UPPER UWCHLAN TOWNSHIP
PLANNING COMMISSION
AGENDA

October 9, 2025
6:00 p.m. Workshop; 7:00 p.m. Meeting

V.	500 Pottstown Pike / Chester Springs Service Center – Final Land Development Plan Review consultants' comments of the Final Plan dated September 3, 2025. Potential to make a recommendation to the Board of Supervisors.	99
VI.	Meeting Updates ~ Reports A. Environmental Advisory Council (EAC) B. Historical Commission (HC)	
VII.	Comprehensive Plan 2025 ~ Review Implementation Recommendations	
VIII.	Approval of Minutes: September 11, 2025 Meeting minutes	144
IX.	Next Meeting Date: November 13, 2025 7:00 p.m.

TYPICAL PORSCHE MONUMENT SIGN

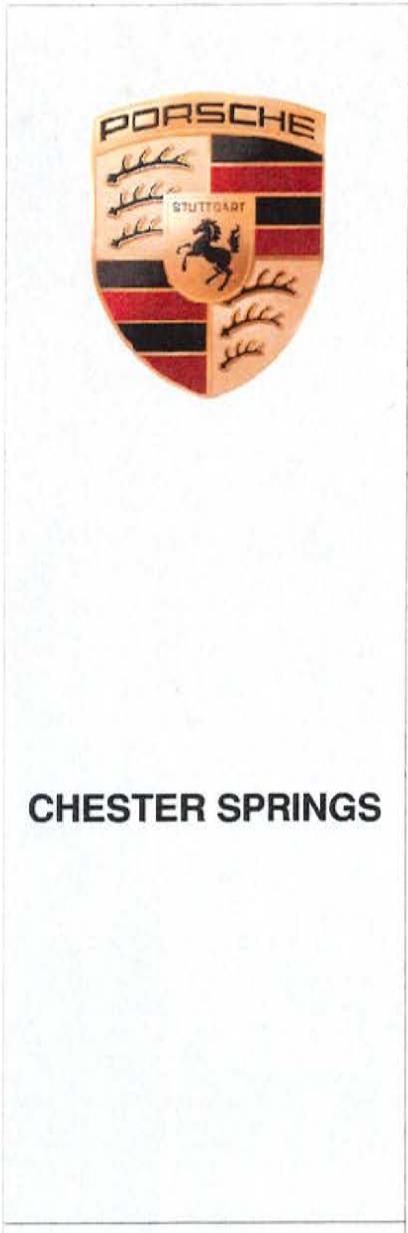
A "Monument Sign" detail has been added (Sheet 17). **We understand that a "decorative wall" is also proposed; a detail for this wall shall be provide and added to the plans to permit the Township to determine whether this Condition of Approval has been satisfied.**

T&M Response: Comment Addressed. The monument sign detail has been added to the plans. (Sheet 16). The proposed landscaping has been verified.
